UNITED STATES PATENT AND TRADEMARK OFFICE

APPLICATION NO.	FILING DATE	FIRST NAMED INVENTOR	ATTORNEY DOCKET NO.	CONFIRMATION NO.
09/893,524	06/29/2001	Paul D. Perry	51481-5069	2982

Office Action Summary

DETAILED ACTION

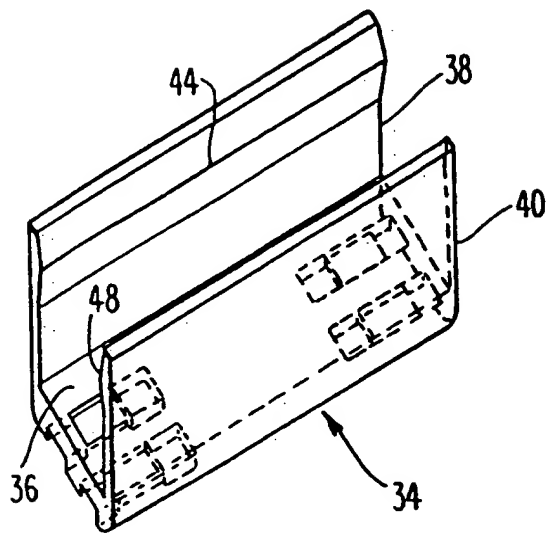
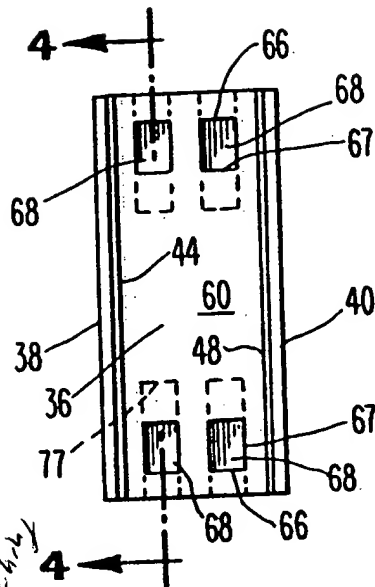
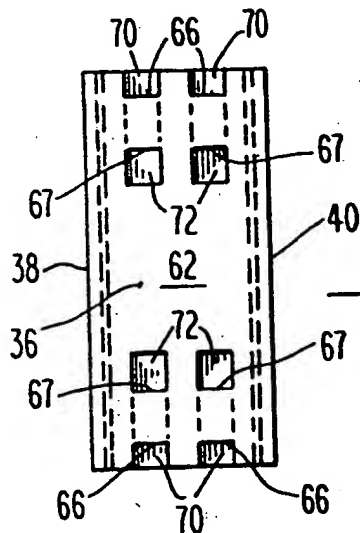
Claims 1-4 and 14-18 are rejected under 35 U.S.C. 102(b) as being anticipated by Mason et al. ("Mason"). Mason discloses a mount 30 for an electrical device 12 including a body and a plurality of electric contacts 18, the body having a base and at least one lateral face extending from the base, and the plurality of electric contacts projecting a first distance from the base (see attachment), the mount comprising: an electric terminal 32 including a solder portion (see attachment) being adapted to be soldered to at least one of the plurality of electric contacts; and a platform (the portions of transverse portion 36 sandwiched between the terminal and the base) adapted for spacing at a second distance the base from the solder portion electric terminal, the second distance being substantially equal to the first distance (see attachment).

Per claim 2 the electric terminal extends along an axis and comprises: a first portion having a first cross-section transverse with respect to the axis; and a second

portion having a second cross-section transverse with respect to the axis, the second cross-section being smaller than the first cross-section (see attachment).

Per claim 4, the first and second cross-sections are generally rectangular, the first portion comprises a first width transverse with respect to the axis and a first height transverse with respect to the axis and perpendicular to the first width, and the second portion comprises a second width transverse with respect to the axis and a second height transverse with respect to the axis and perpendicular to the second width, and the second height is less than the first height (see attachment).

Fig. 5

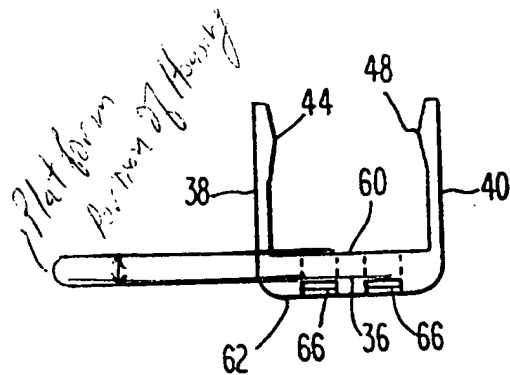
Per claim 3, the platform is adapted to be contiguously sandwiched between the base and the second portion.

Platform portion sandwiching terminal

Fig. 4

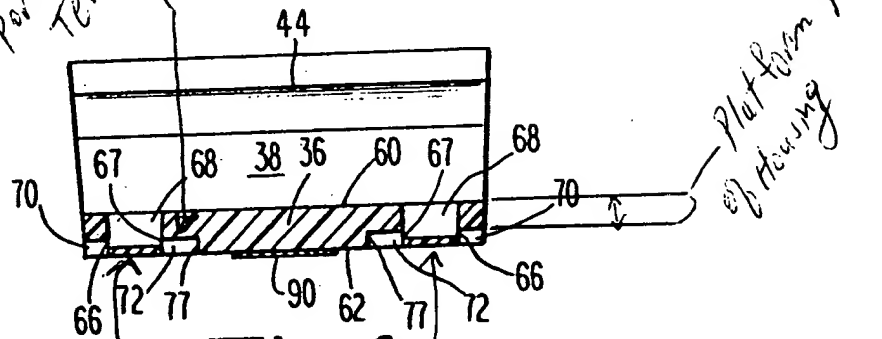
Per claim 14, the mount further comprises a housing supporting the terminal such that the terminal is contiguously sandwiched between the housing and the platform (see attachment).

Housing portion sandwiching terminal
